**6 Parsifal Road
NW6 1UH**

**Basement Impact Assessment
Audit**

For
London Borough of Camden

Project Number: 12727-28
Revision: F1

Job Number 170823	Date Oct '17
Dwg Number SL-10	Rev 2
Drawn SB	Chkd EP
Scale As shown @ A3

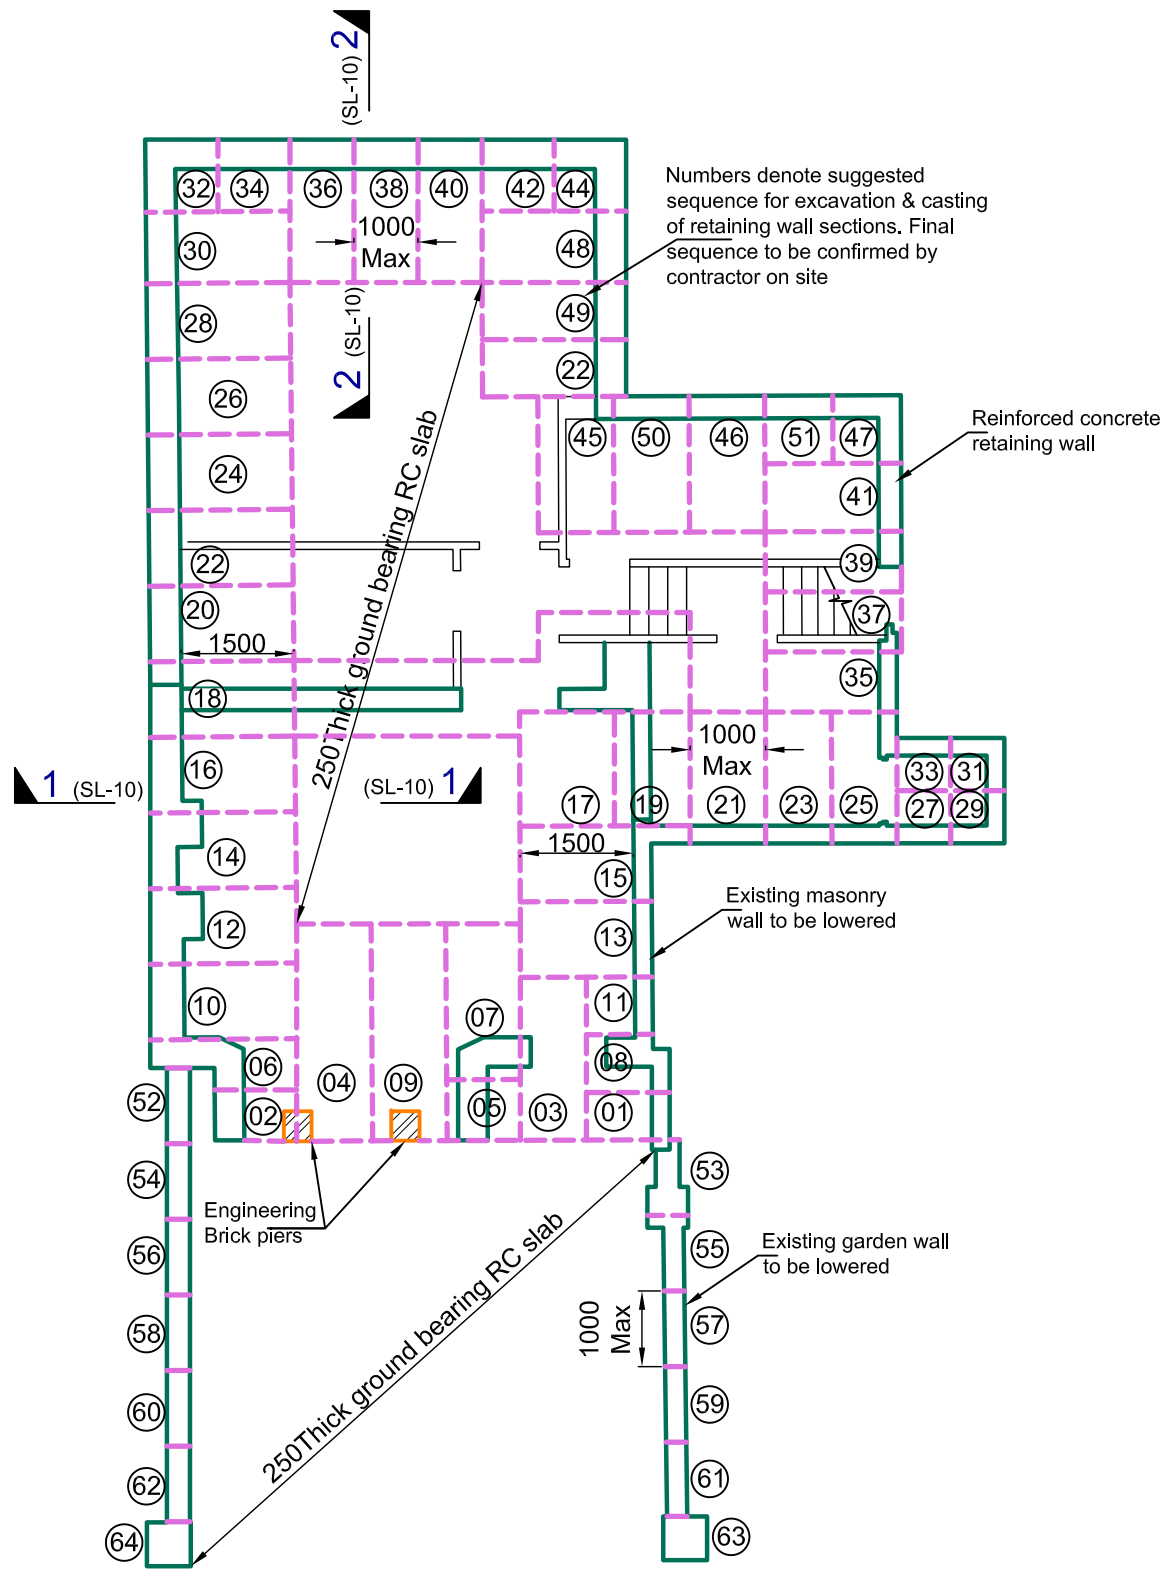
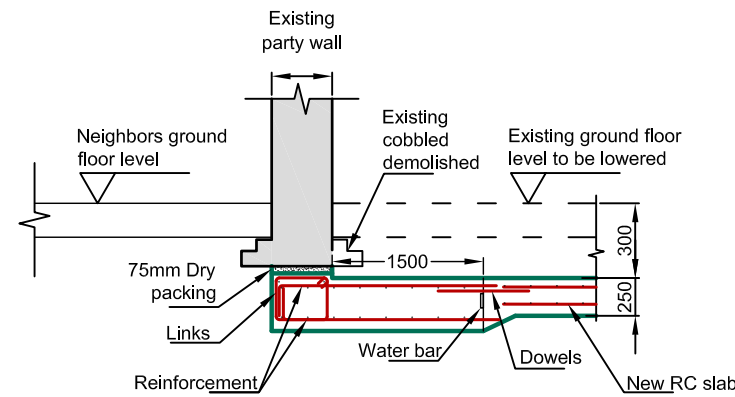
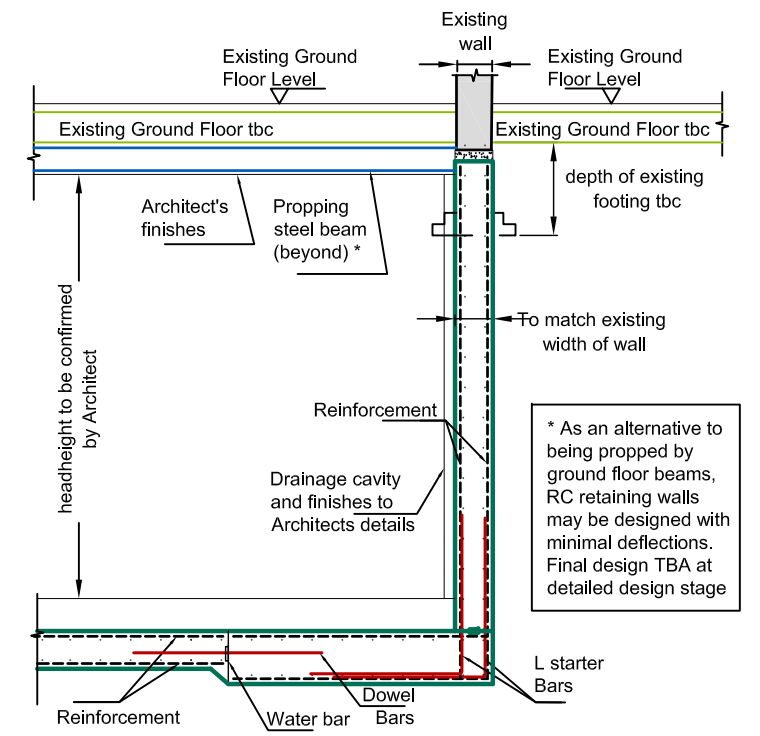
- Steel beams at the head of the retaining walls provide the propping required.
- The distance between the adjoining steel beams are considered small enough to allow the retaining walls to span between them and transfer horizontal loads to the ground floor steelwork
- The steel arrangement is shown on revised drawings (SL-10-Rev2 and SL-20-Rev2)

Rev	Date	Amendments
2	14/02/18	Minor amendment to Section 2-2 to show wall propping option
1	16/10/17	minor amendments to Architects comments
-	06/10/17	First issue preliminary to Architect
